**Planning Department
Transportation Development Services**

**Re: Davita Dialysis Center - Albuquerque, 5207 San Mateo Blvd.
Traffic Circulation Layout
(F17-D095A)**

Based upon the information provided in your submittal received 3-04-15, the above referenced plan cannot be approved for Building Permit until the following comments are addressed:

DATE	
BY	
REVISION	
No.

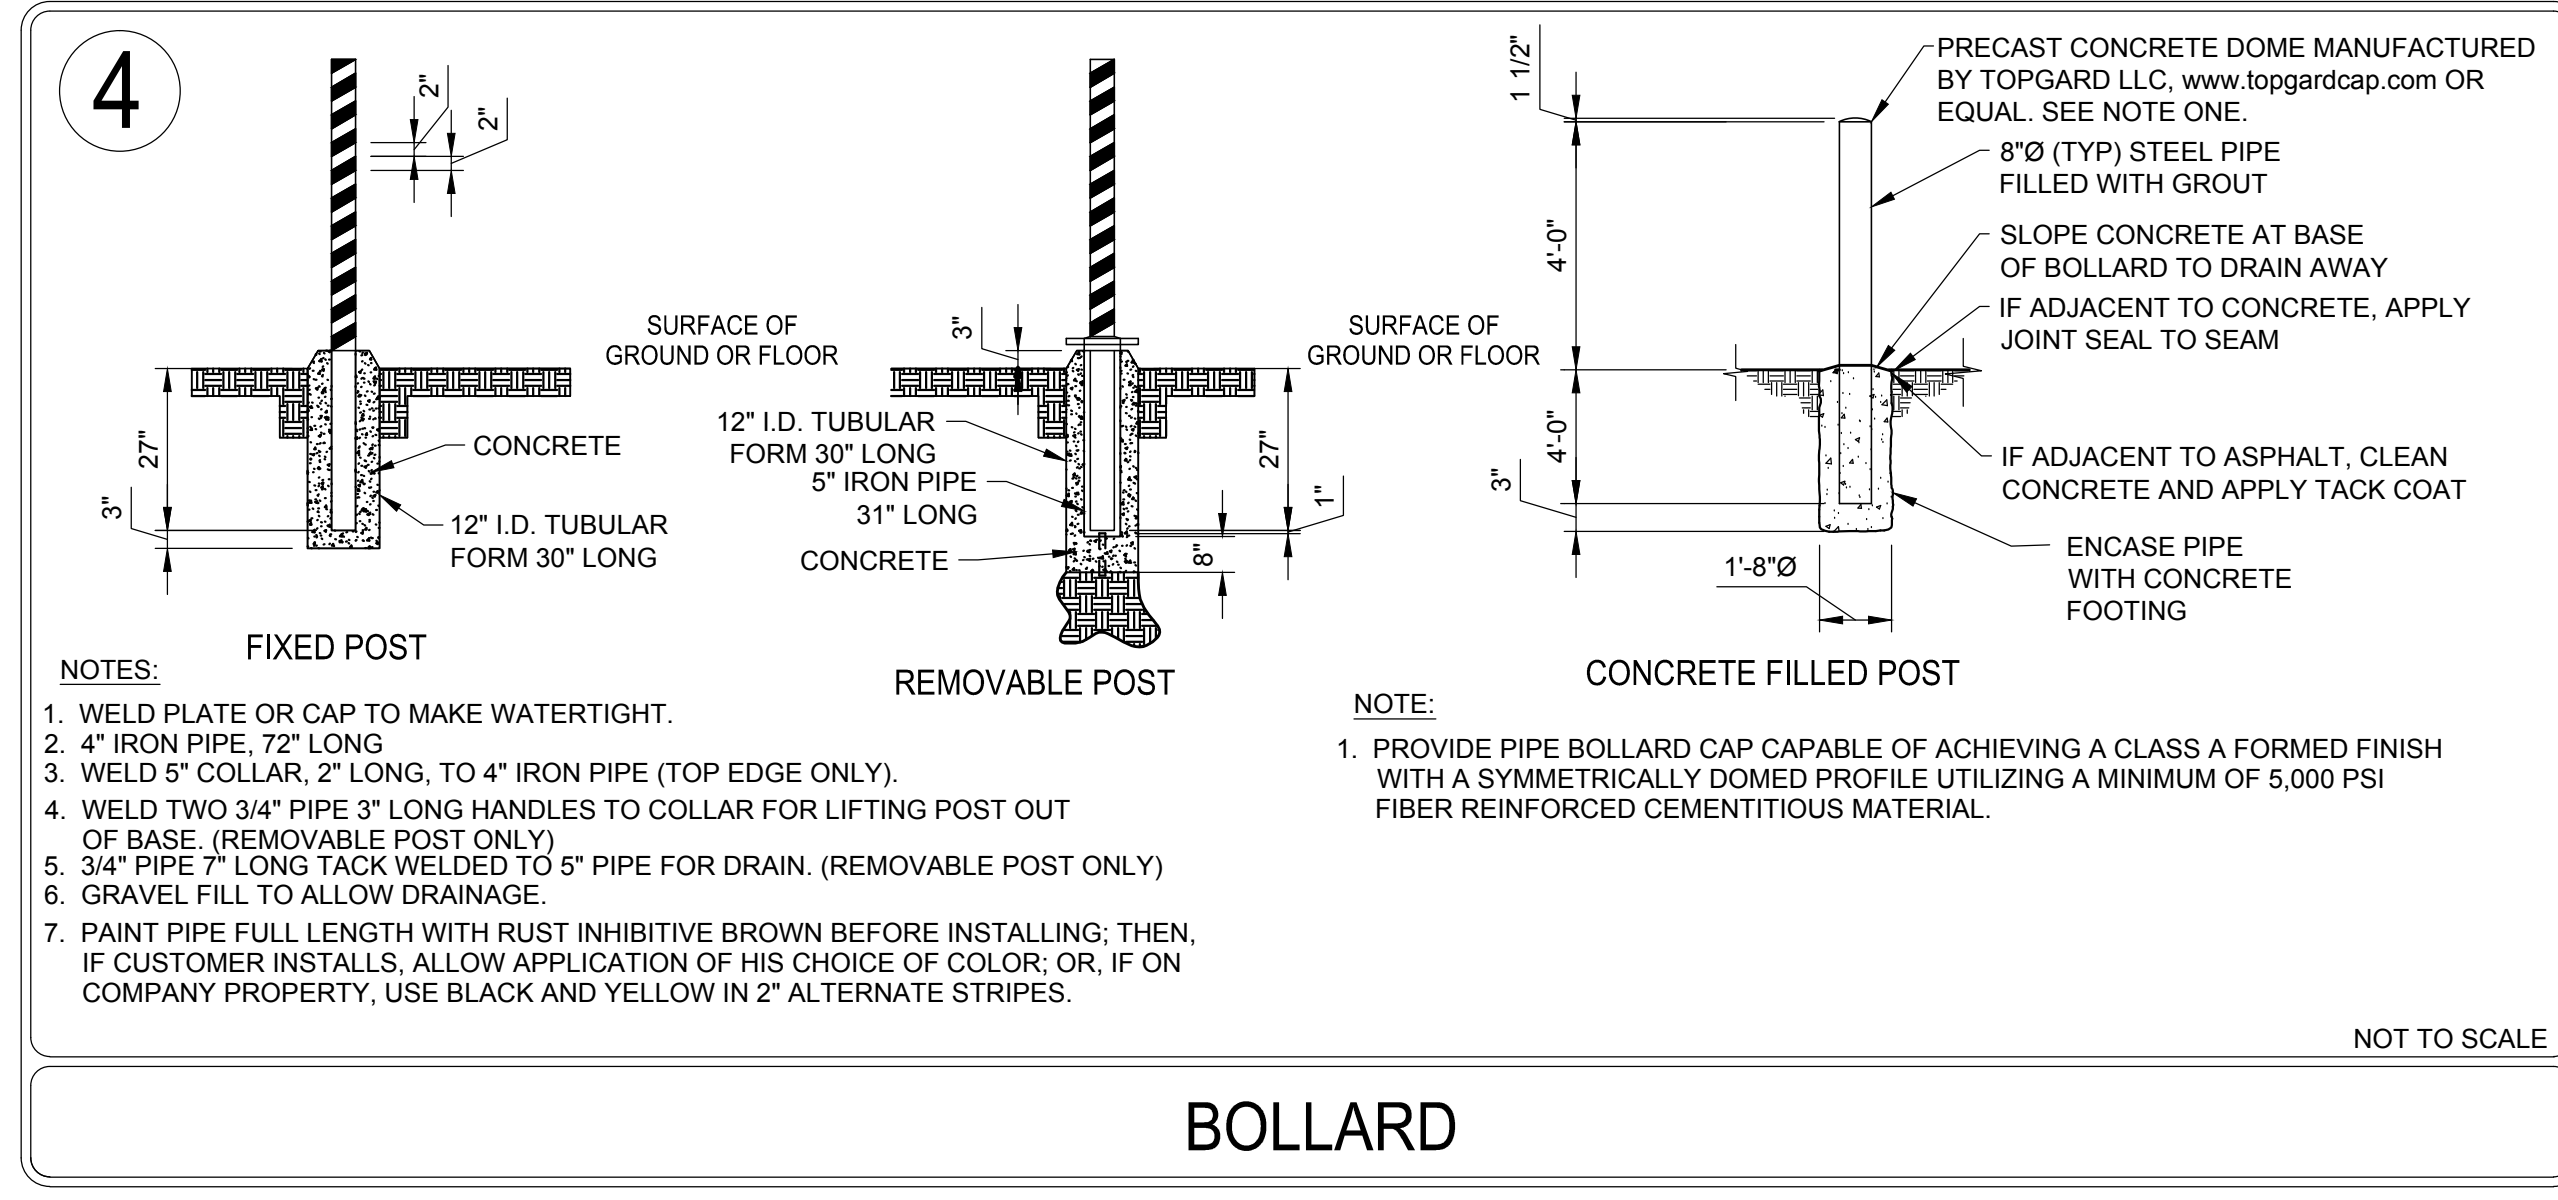
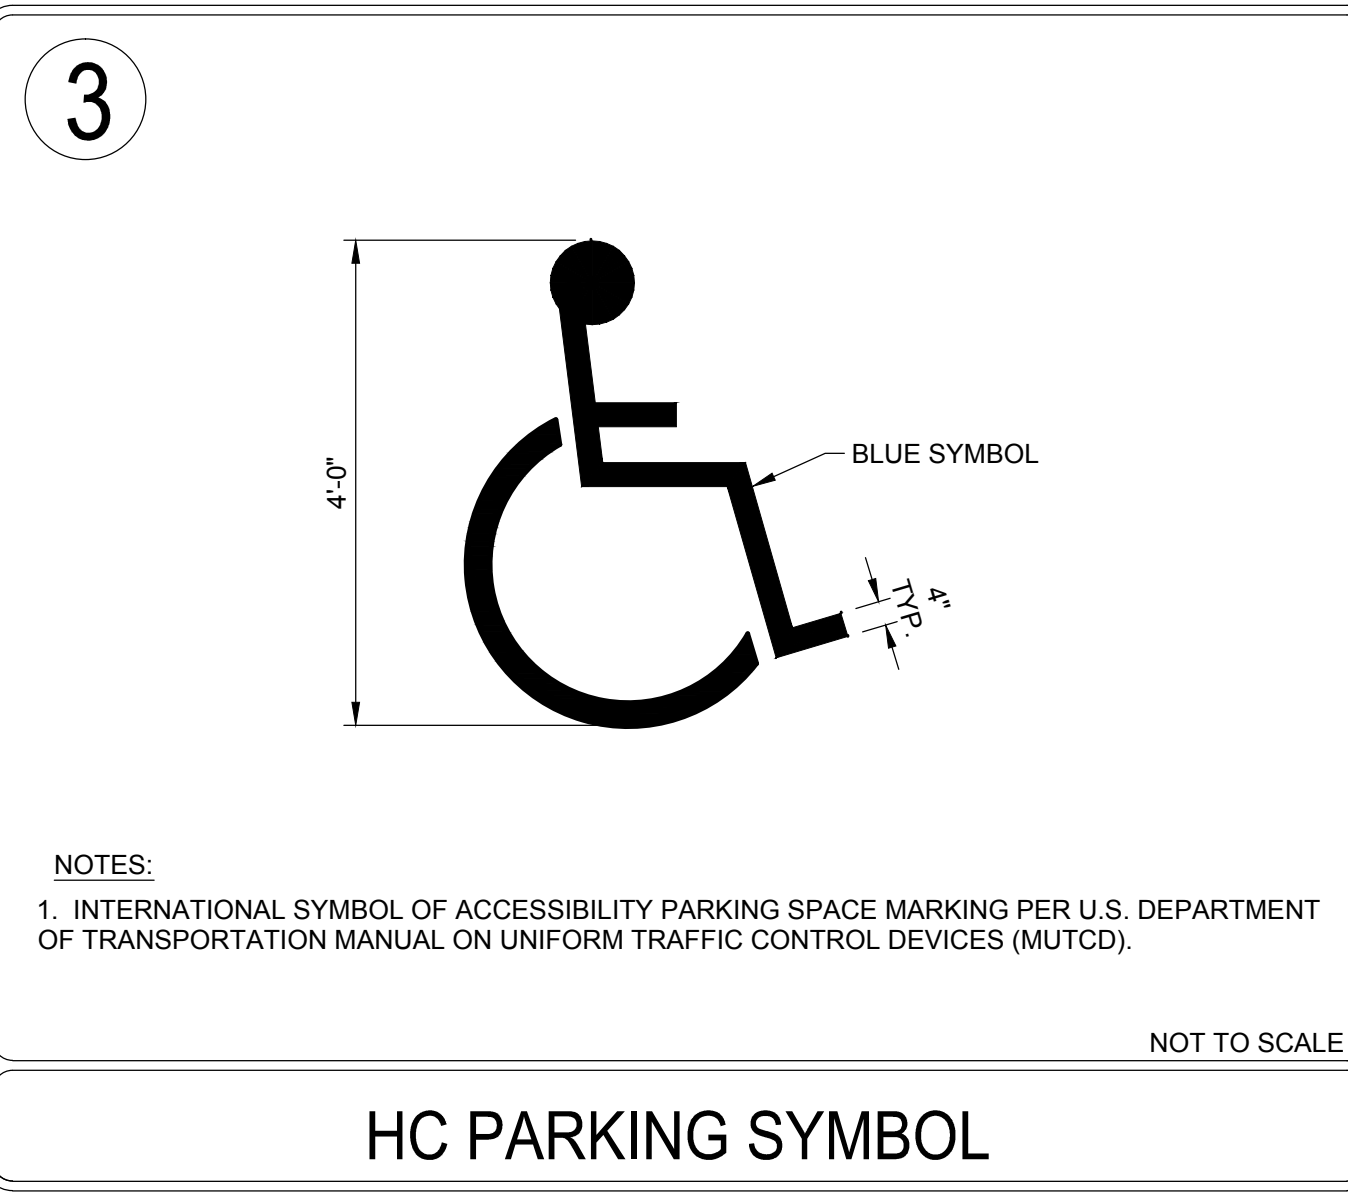
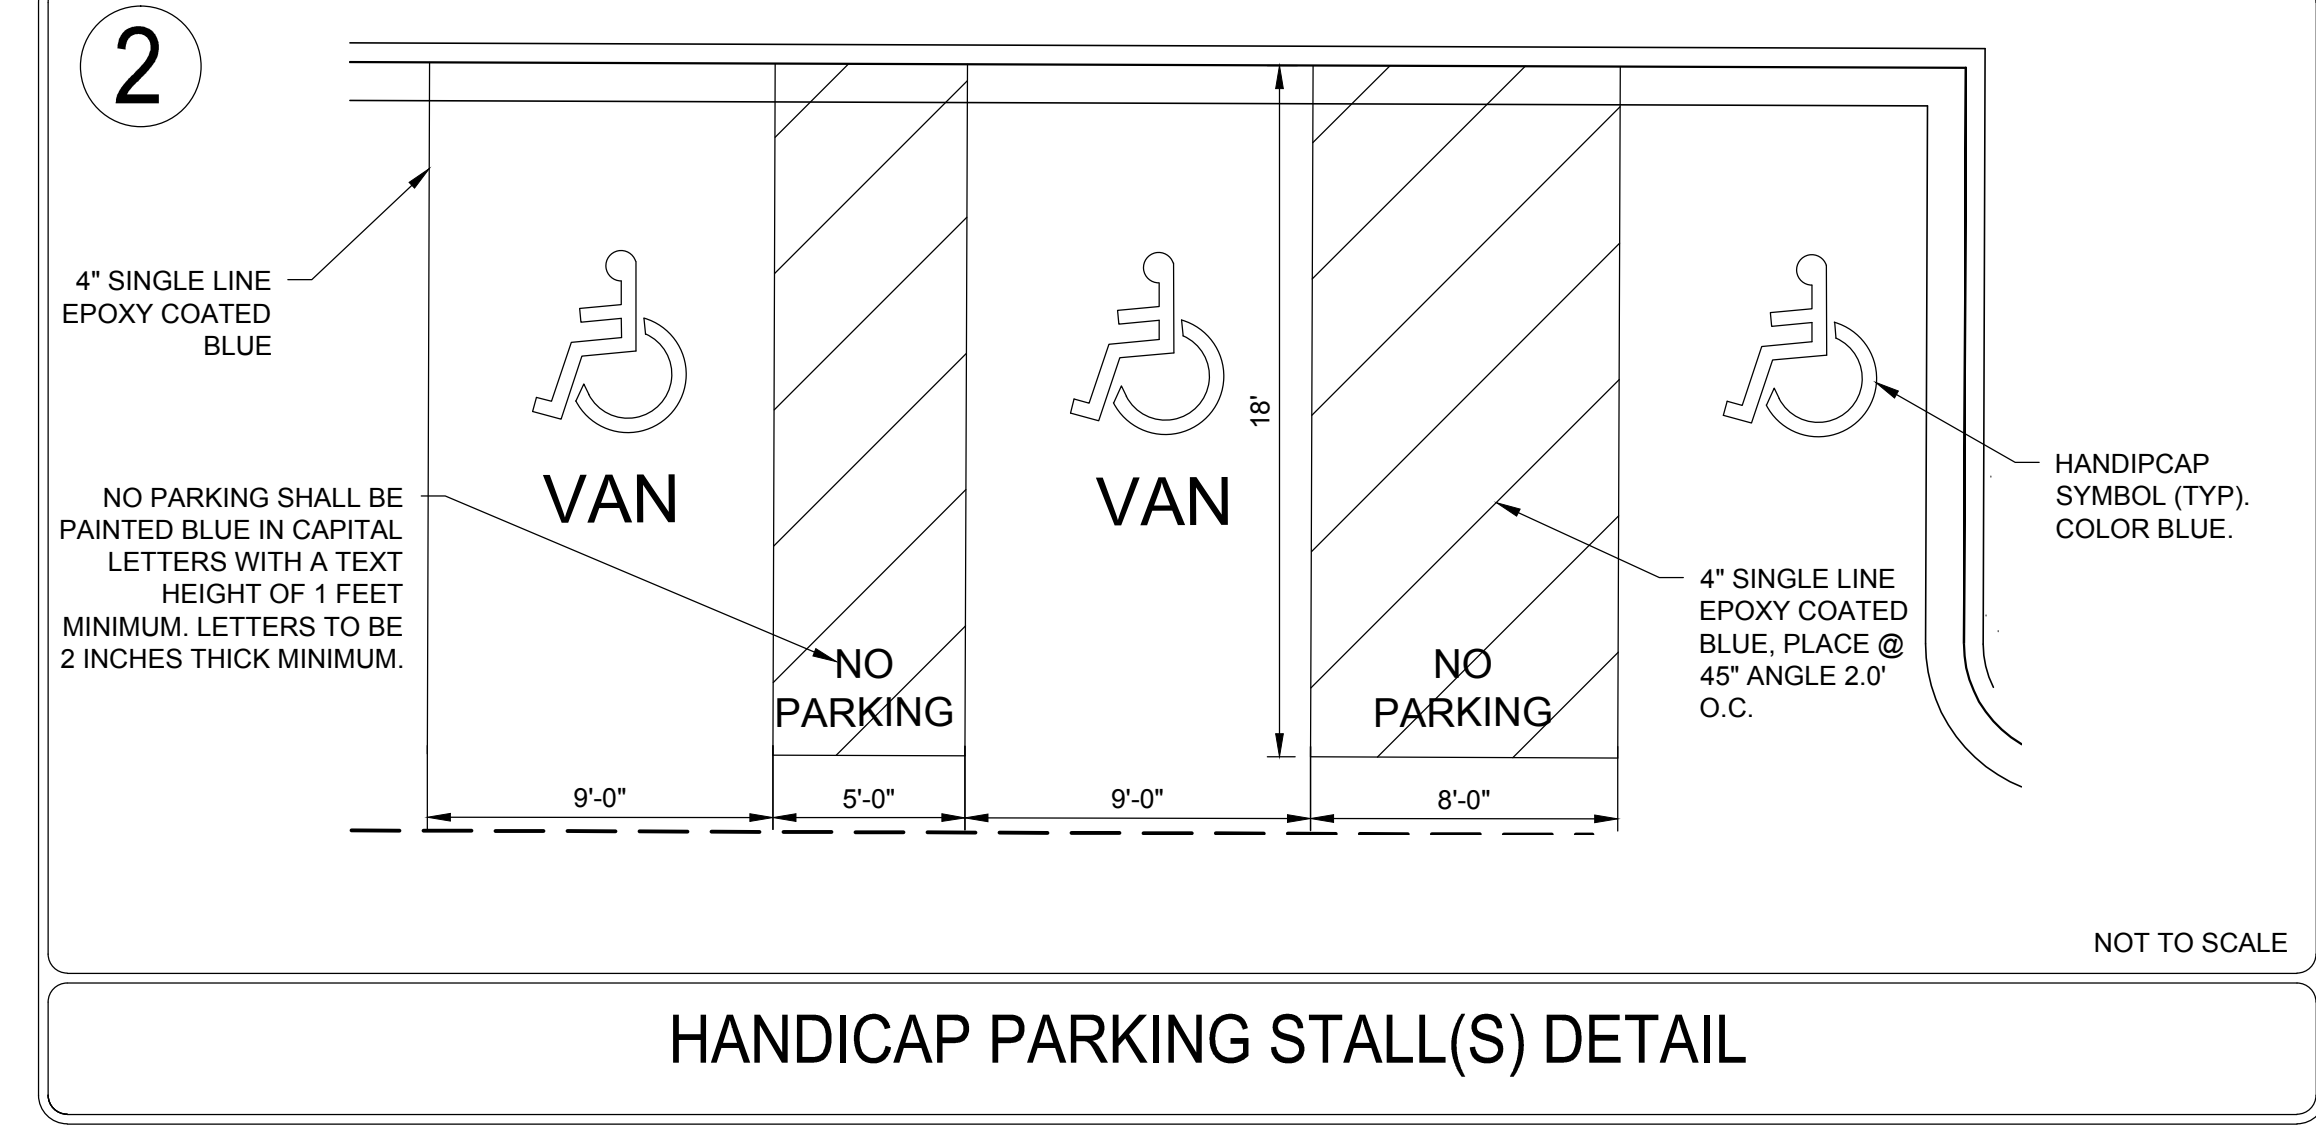
6. The ADA van accessible sign must have the required language per 66-7-352.4C NMSA 1978 **"Violators Are Subject to a Fine and/or Towing."**
7. Per the DPM, a 6 ft. wide ADA accessible pedestrian pathway is required from the public sidewalk to the building entrances and from the HC parking stall access aisles to the building entrances. Clearly show this 6-foot wide ADA pathway, and if the "Existing ADA Ramp to Remain" needs to be upsized to provide a 6-foot ADA accessible route, remove and replace this ramp to meet
